MARTIN S. BURCK ASSOCIATES, INC.

Subject: Response to January 5, 2023, Ecology Further Action Letter

North Star Casteel (Formerly Varicast Inc.)
1200 West 13th Street
Vancouver, Washington
VCP Identification: SW1712

YEAR: 1955

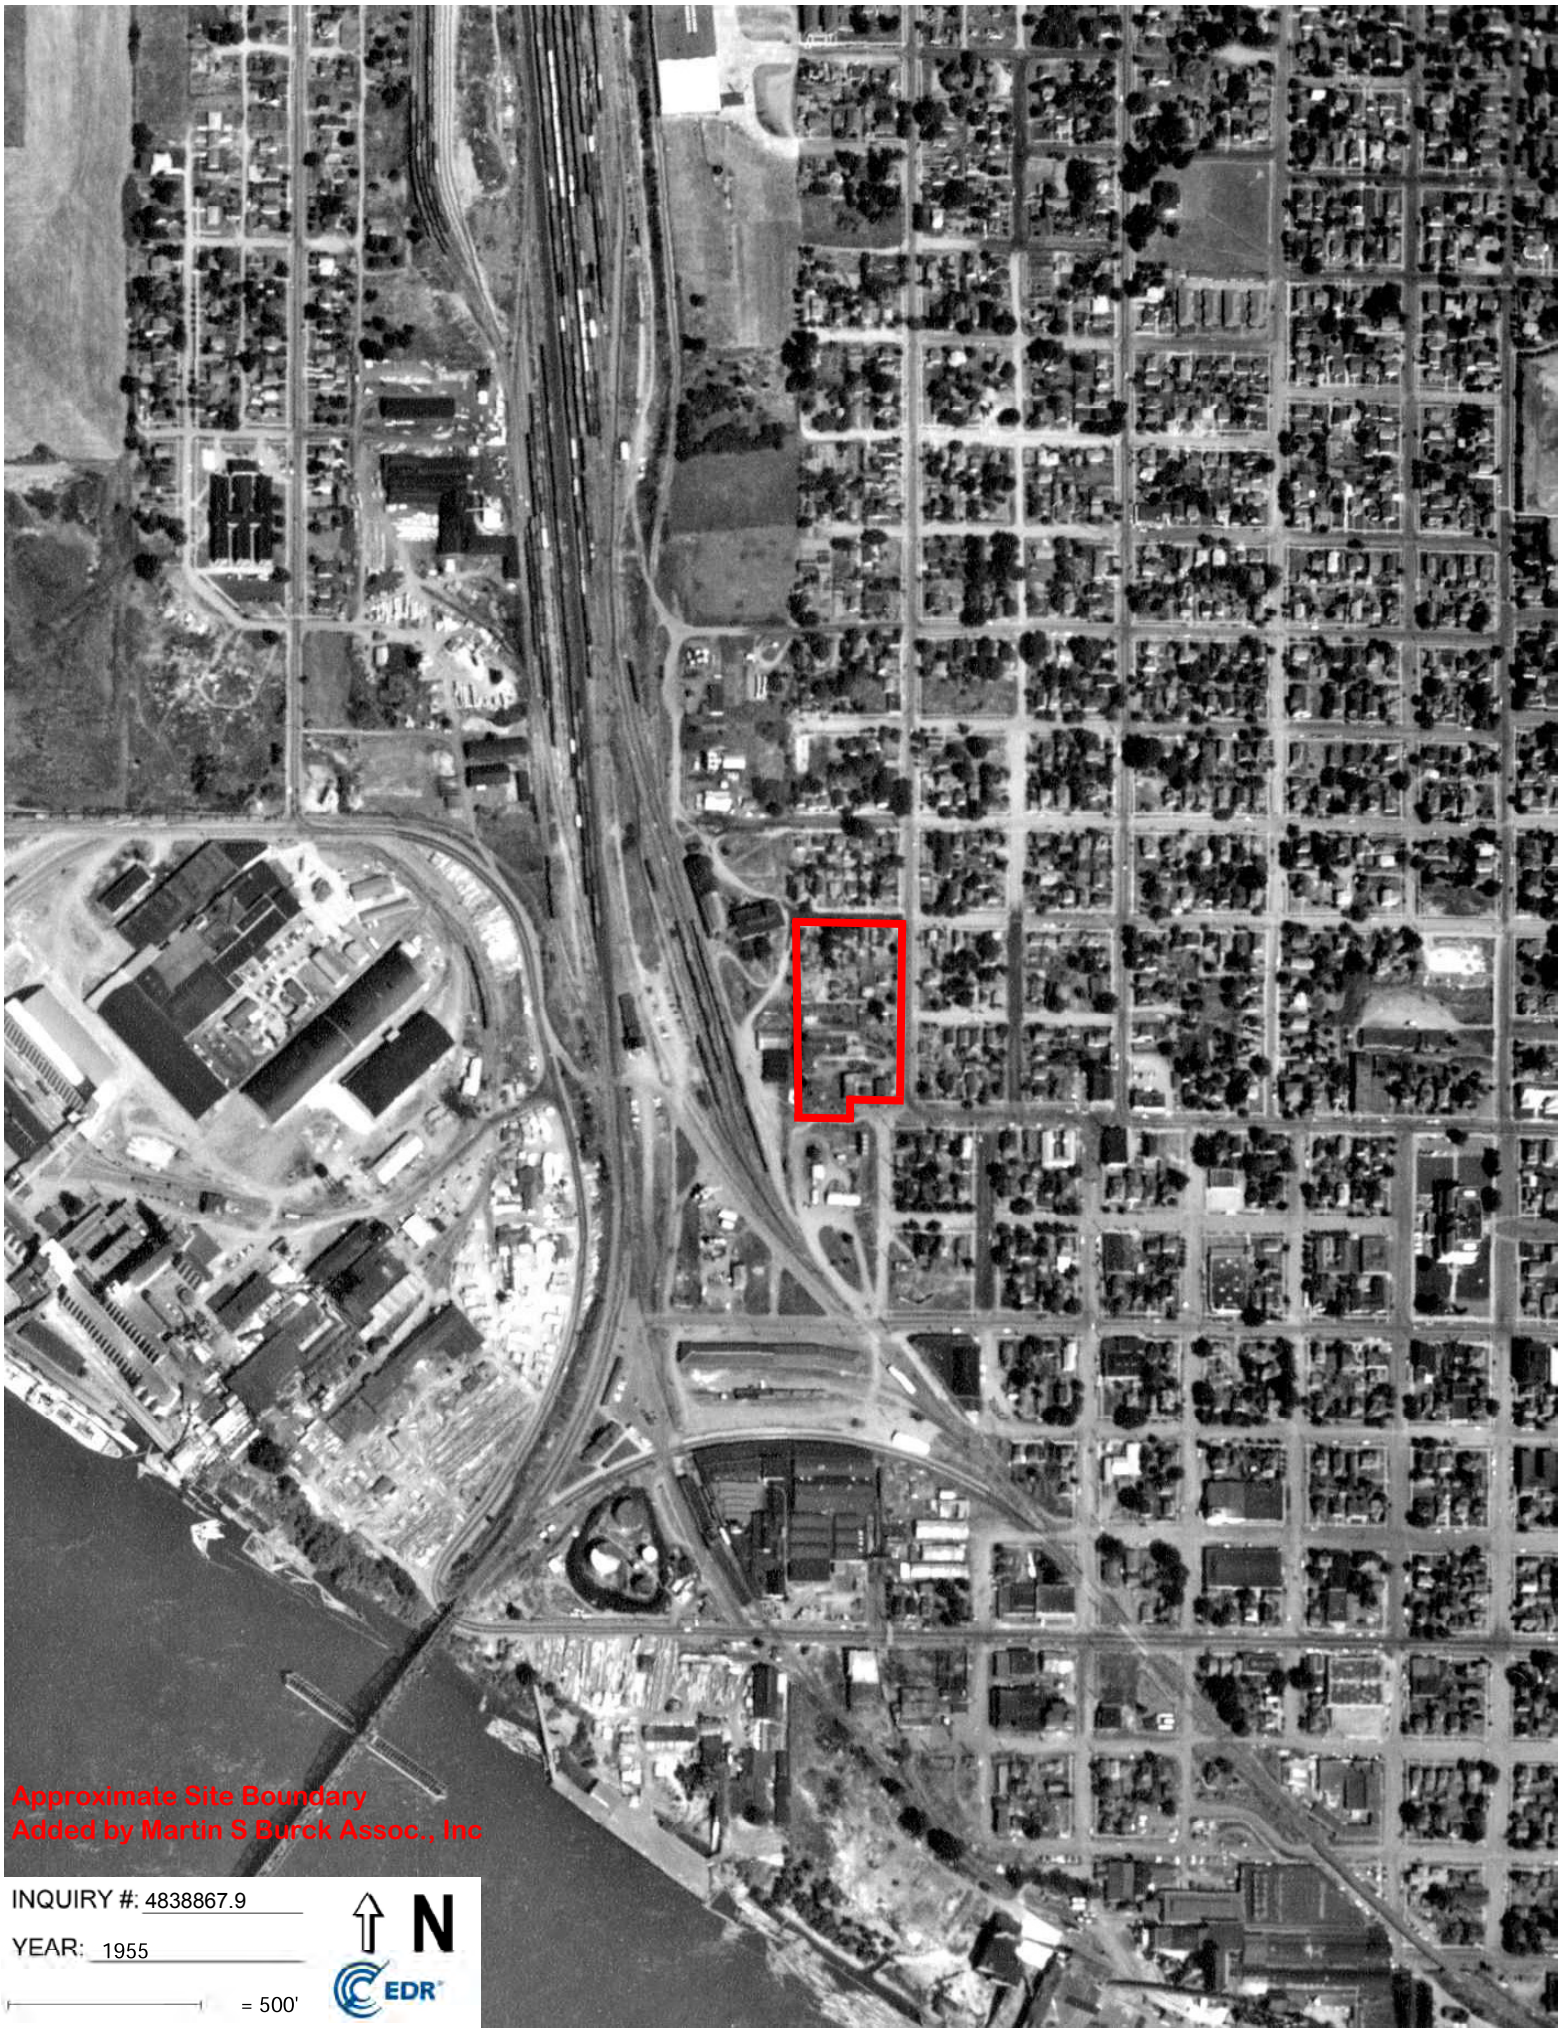
- **1955:** Basically, same configuration of buildings; although, sister building appears adjacent to foundry building and extends off-Site to the west. **MSBA:** The image resolution is low on this aerial image, but we do not see a new sister building adjacent to the foundry or extending off-site. The absence of the building extending off-site is also supported by the 1966 Sanborn Map. The 1955 aerial image did not have the approximate property boundary in red, which I've added to the version shown in Attachment D.
